## Oyster Point Marina West Basin Access Improvements (Contract 2024-04)

### ADDENDUM NO. 1 RESPONSE TO QUESTIONS

FROM: San Mateo County Harbor District

DATE 04-10-2024  
SHEET 8 OF 25  
**C-012**

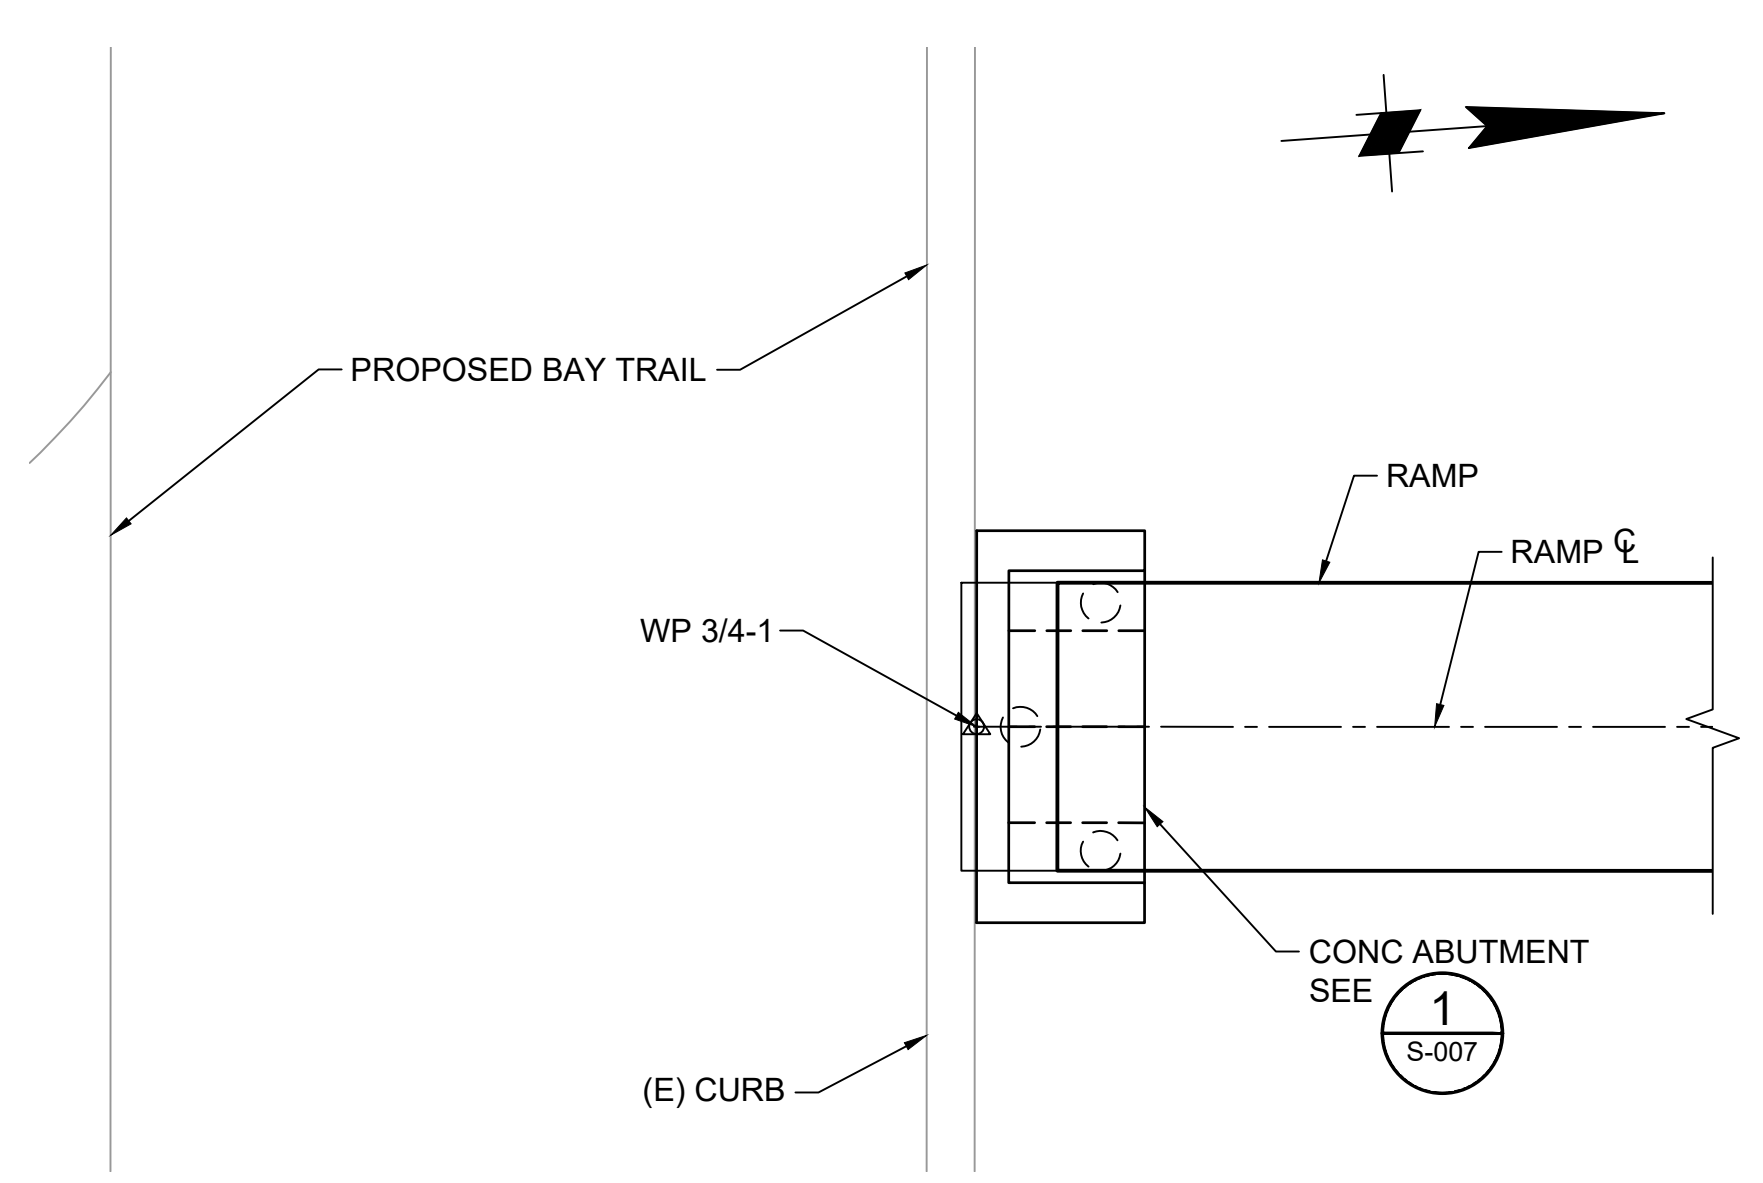
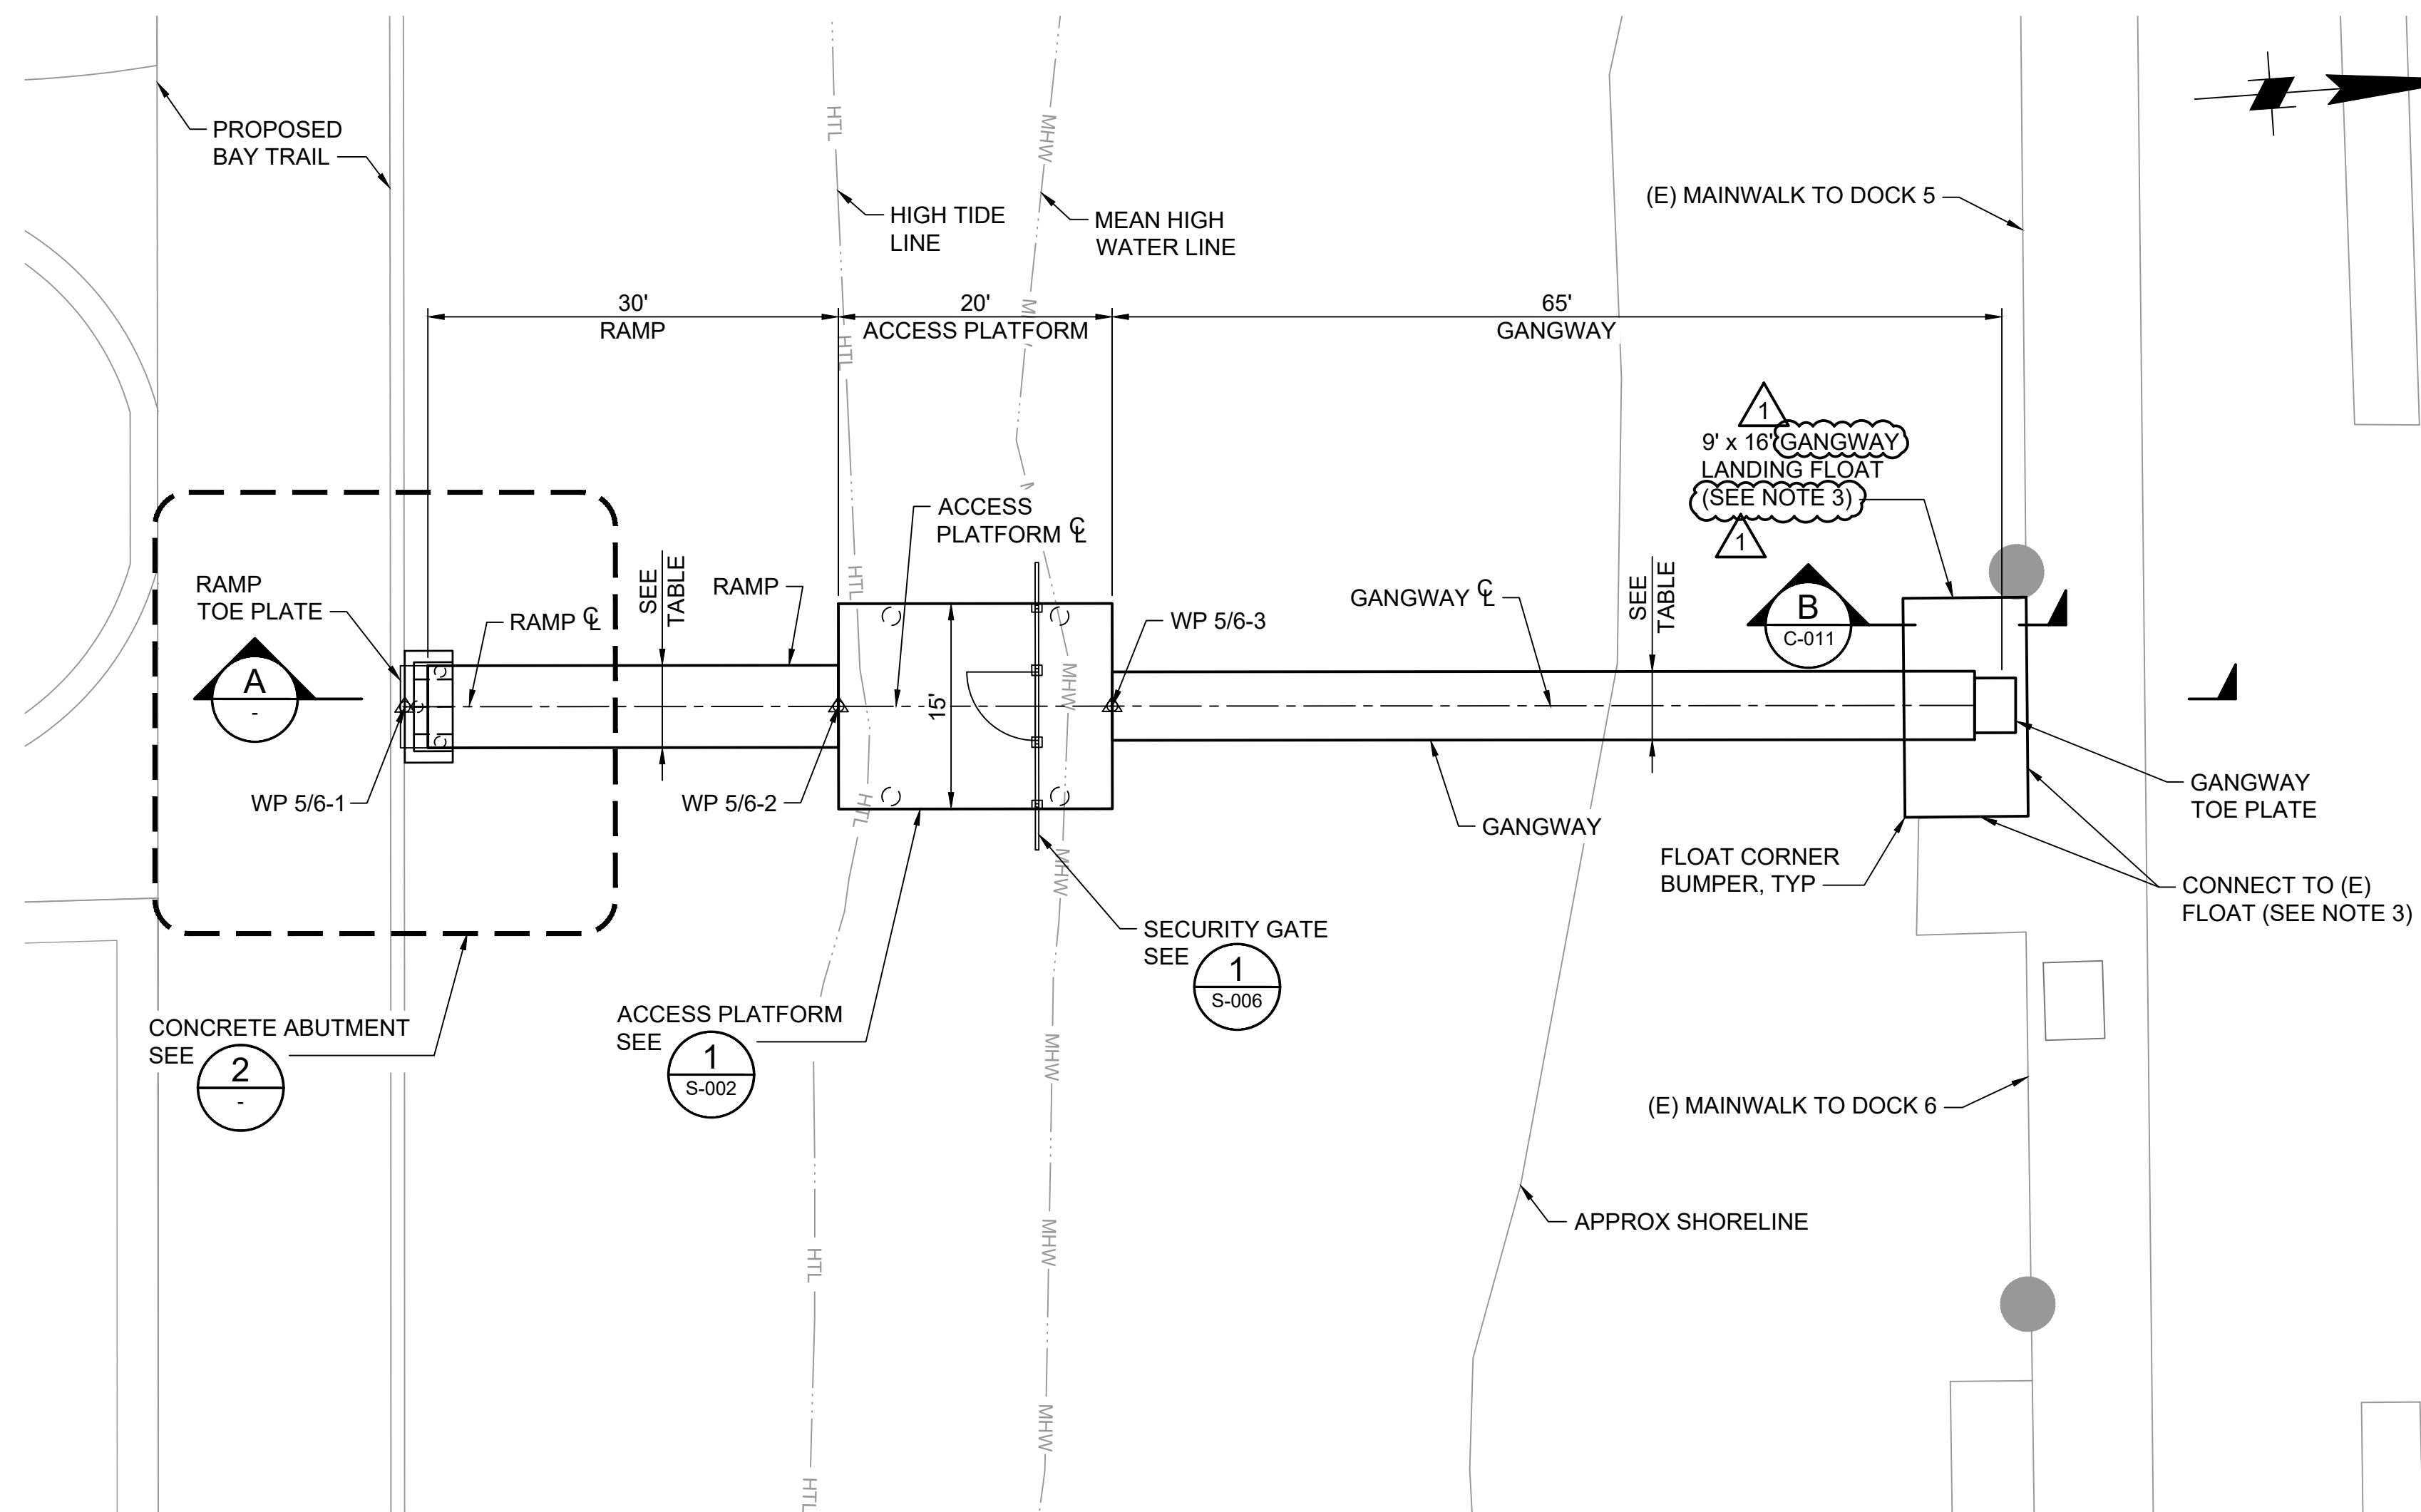
Question 14: The plans call for the gangway landing floats to be concrete floats. Spec Section 024800-7 Part 2 provides a list of acceptable floats to be used for various types of floats such as concrete, timber, and aluminum. Please clarify if these gangway landing floats are to be concrete floats.

1. Plan View:
  - a. Revise callout from “9’ x 16’ concrete landing float” to “9’ x 16’ gangway landing float (see note 3).”

District response: The gangway landing floats may be concrete, timber, or aluminum as specified. Plan view callouts on sheets C-12 and C-13 will be revised from "concrete landing float" to "gangway landing float."

DATE 04-10-2024  
SHEET 9 OF 25  
**C-013**

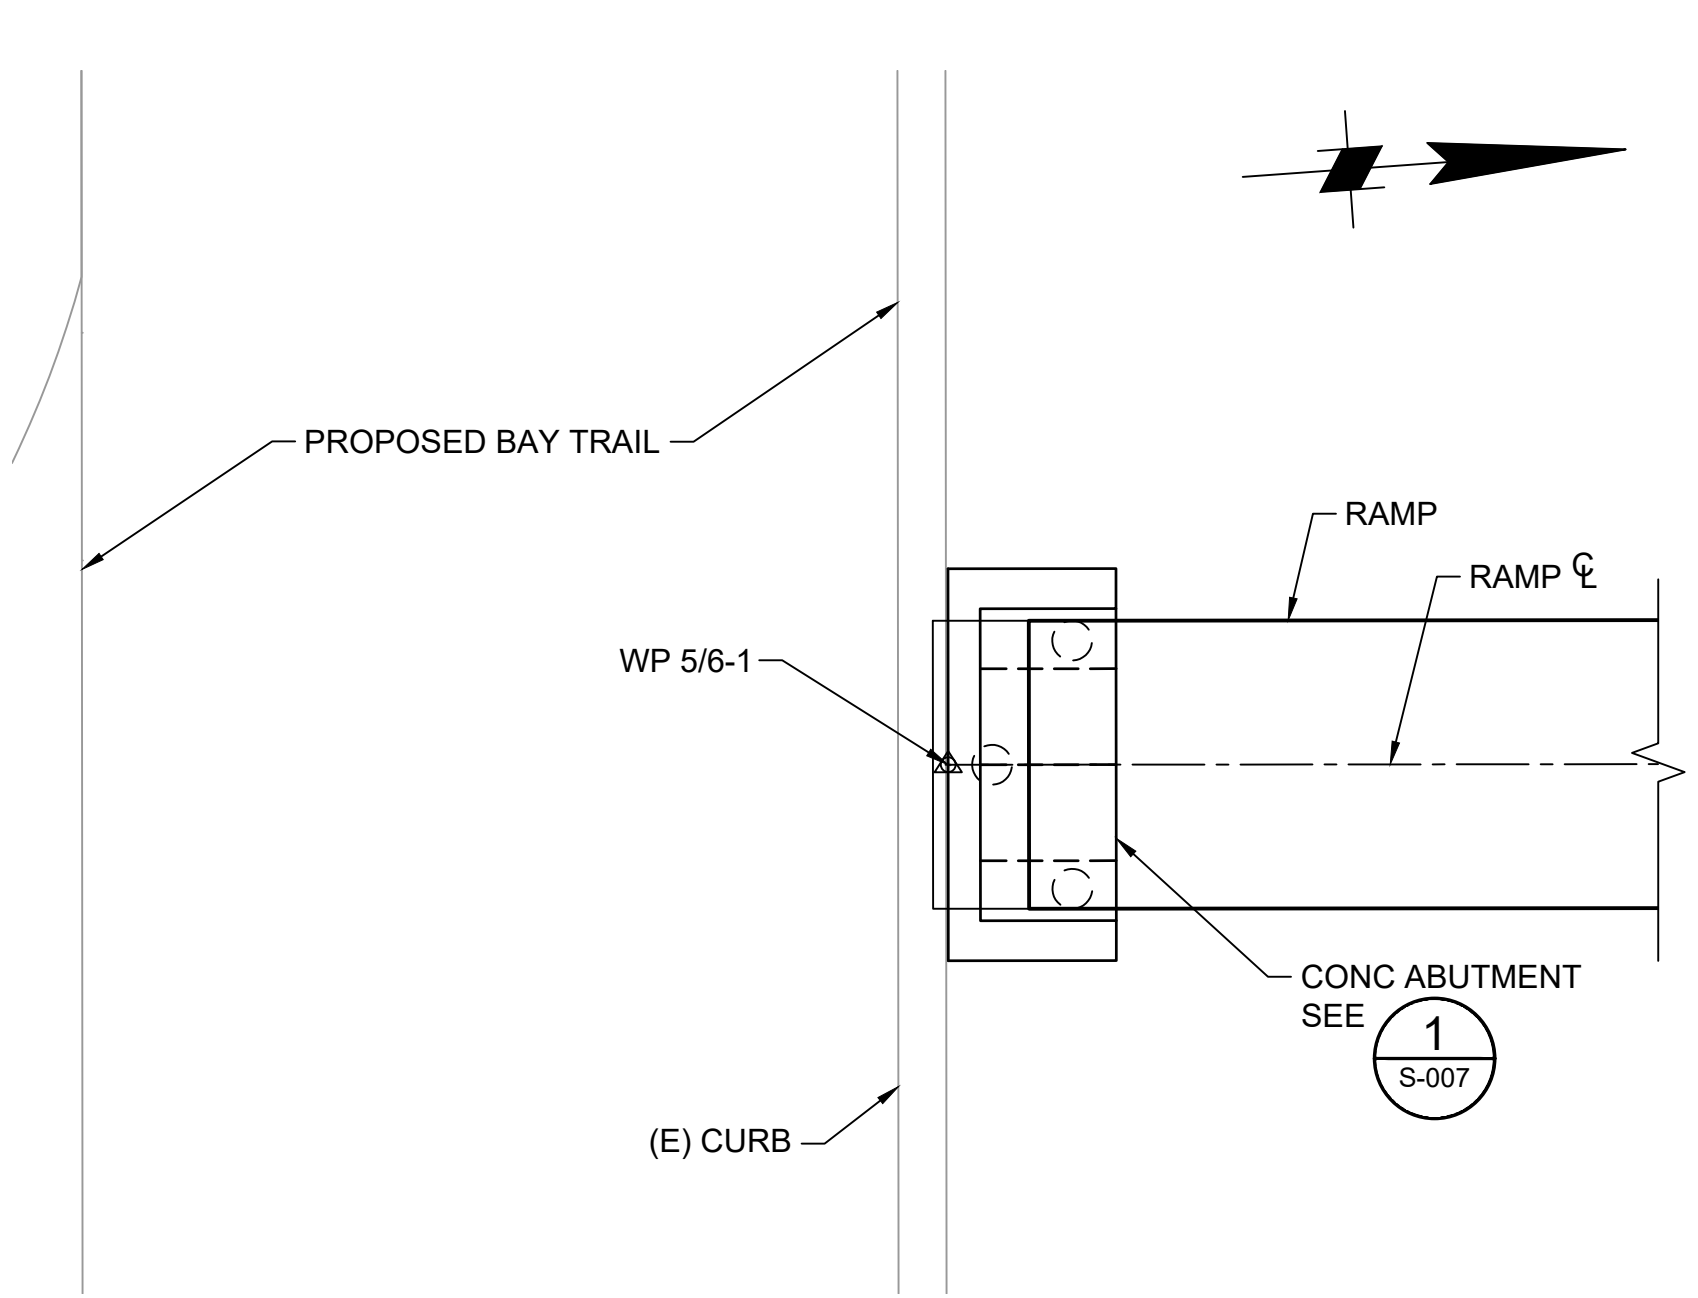
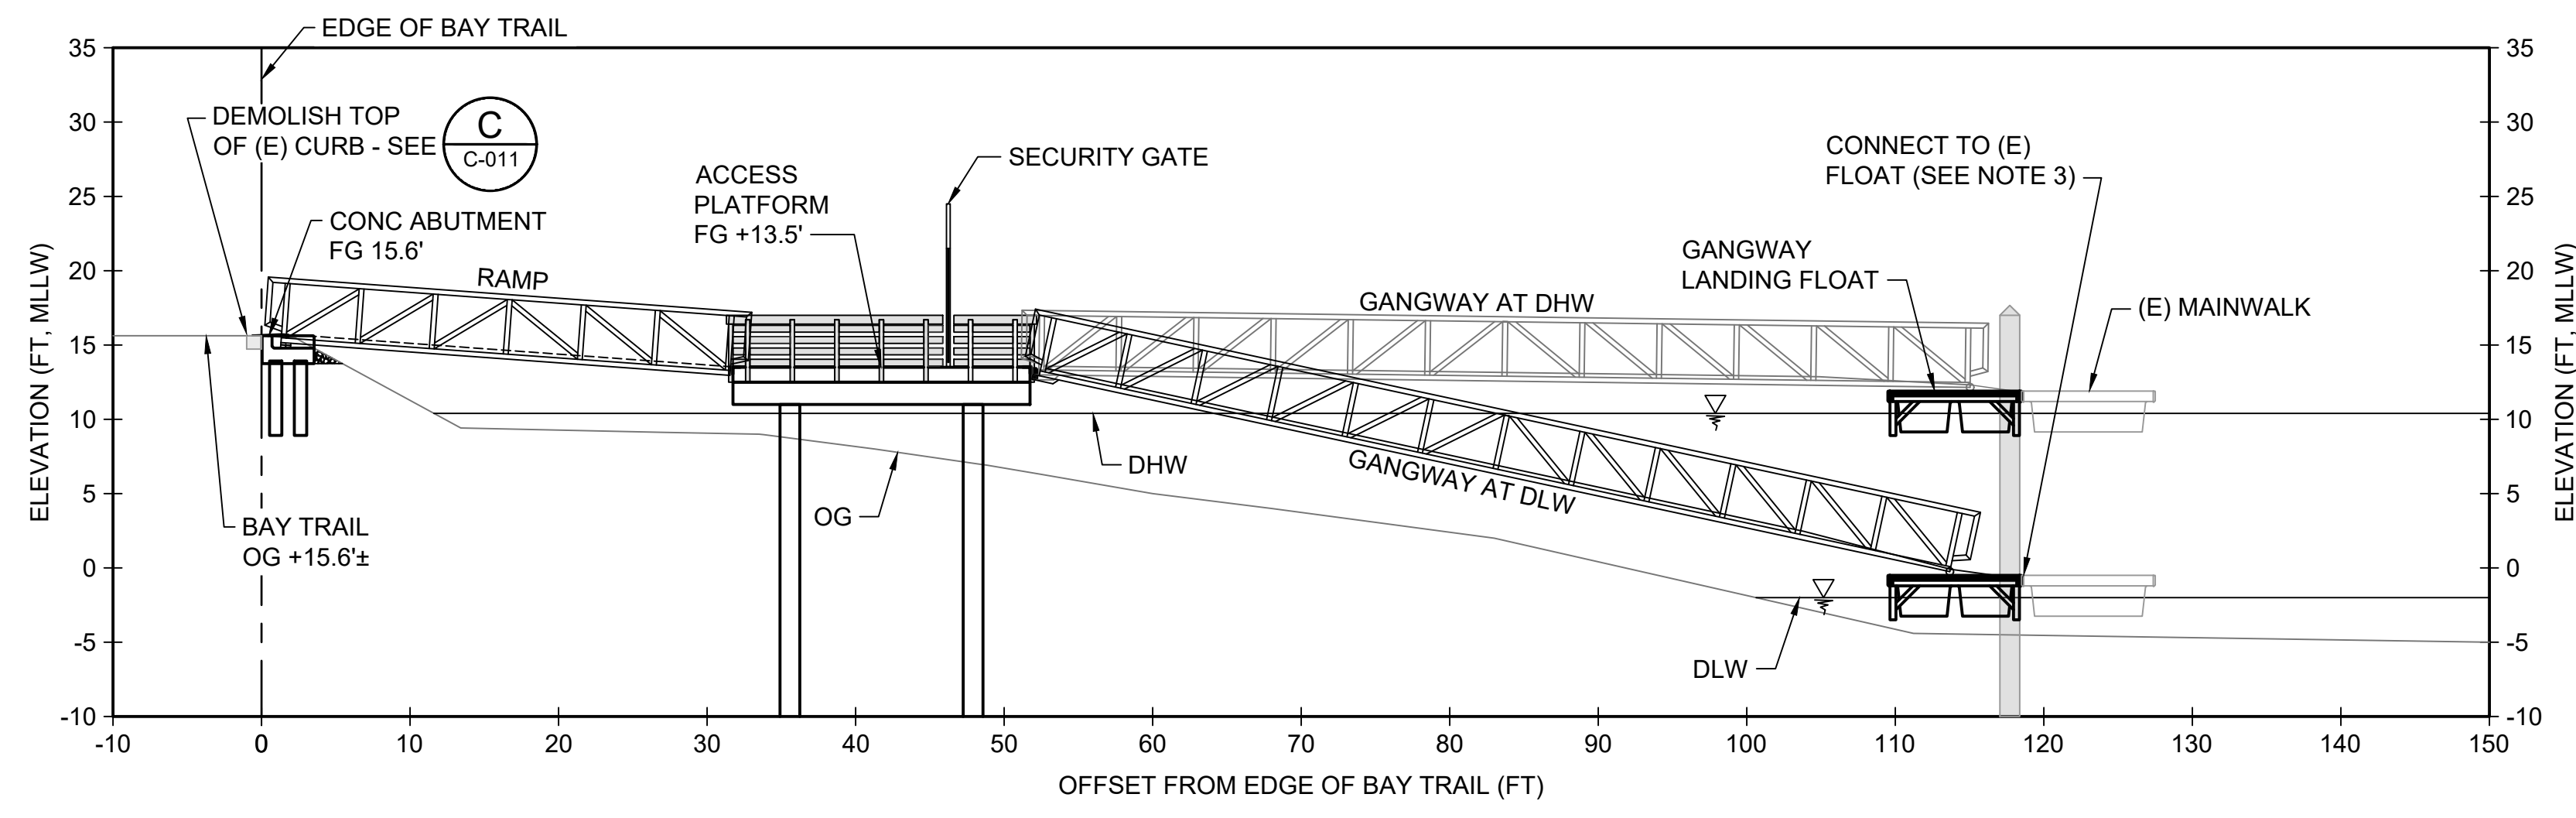
1. Plan View:
  - a. Revise callout from “9’ x 16’ concrete landing float” to “9’ x 16’ gangway landing float (see note 3).”
